PUBLIC WATERMAIN INFRASTRUCTURE PLANS

ZILBER INDUSTRIAL 3 @ LAKEVIEW CORPORATE PARK

August 11, 2026
Village Engineer Comments

SHEET
C-3
C-8

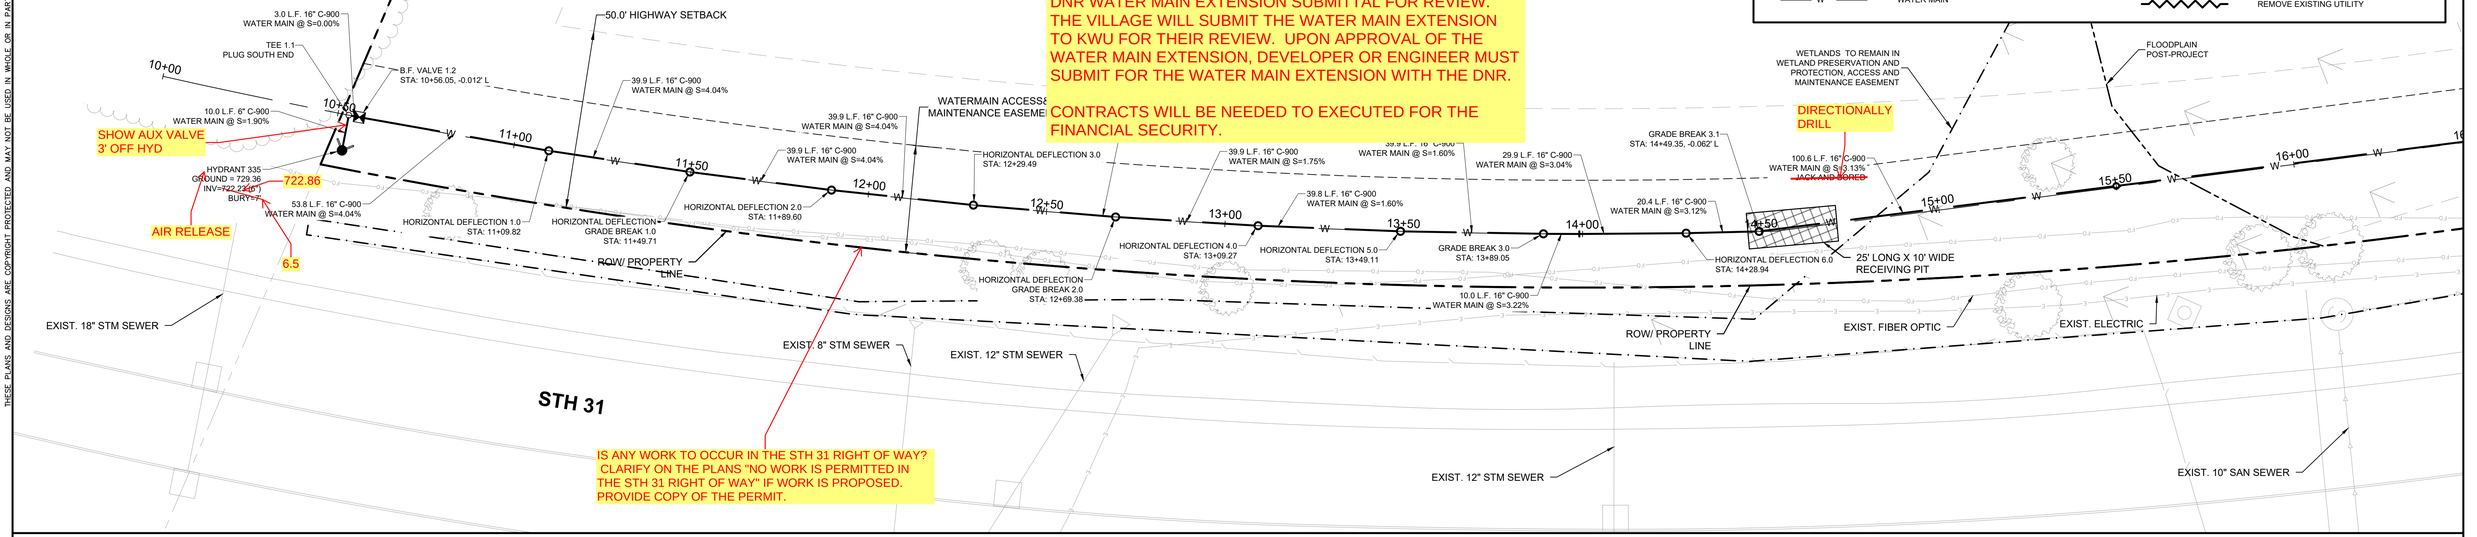
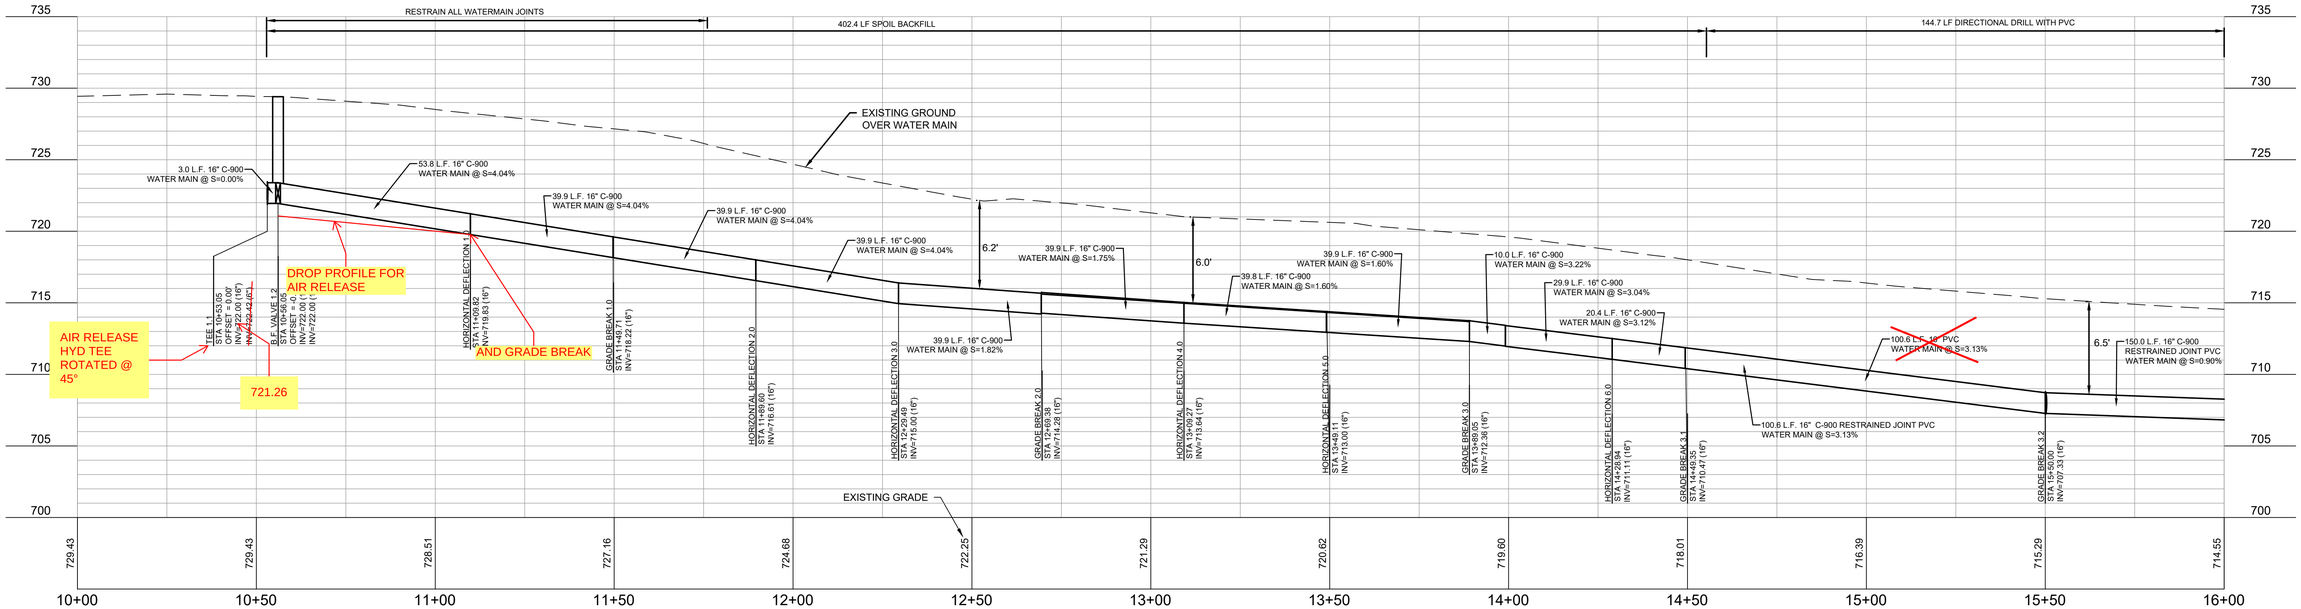
PROVIDE DRAFT PROJECT MANUAL/CONTRACT FOR PUBLIC WATER MAIN IMPROVEMENTS FOR REVIEW. CREATE SOMETHING SIMILAR TO THAT USED FOR CEDAR RIDGE SUBDIVISION (TONY ZANON IS THE ENGINEER) FOR THE MANUAL/CONTRACT. PROVIDE THE VILLAGE THE DRAFT DNR WATER MAIN EXTENSION SUBMITTAL FOR REVIEW. THE VILLAGE WILL SUBMIT THE WATER MAIN EXTENSION TO KWU FOR THEIR REVIEW. UPON APPROVAL OF THE WATER MAIN EXTENSION, DEVELOPER OR ENGINEER MUST SUBMIT FOR THE WATER MAIN EXTENSION WITH THE DNR.

CONTRACTS WILL BE NEEDED TO EXECUTED FOR THE FINANCIAL SECURITY.
